15 ST. VINCENT PLACE SOUTH, ALBERT PARK. (17.09.26).

Further Information Request

This response provides further clarification in relation to the matters outlined in the Further Information Request issued by Heritage Victoria on 21.08.26.

Figure 6 – The photo above is taken from the backyard, looking north towards the existing residence. Pictured here is the existing living room and shed.

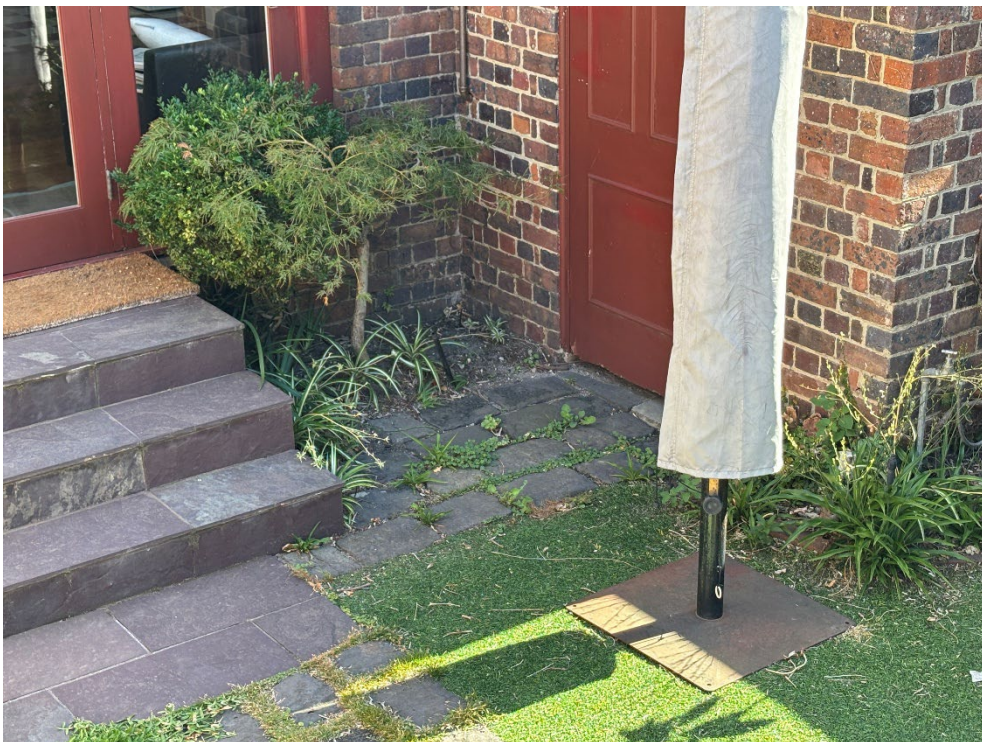
We agree that repurposing the original flagstone pavers as part of the proposed landscaping scheme will be a positive contribution to the balancing of the proposal's heritage impacts. Notes on HV02 and HV05 have been added to this effect. Refer to Figure 6 and 7 in the appendix.
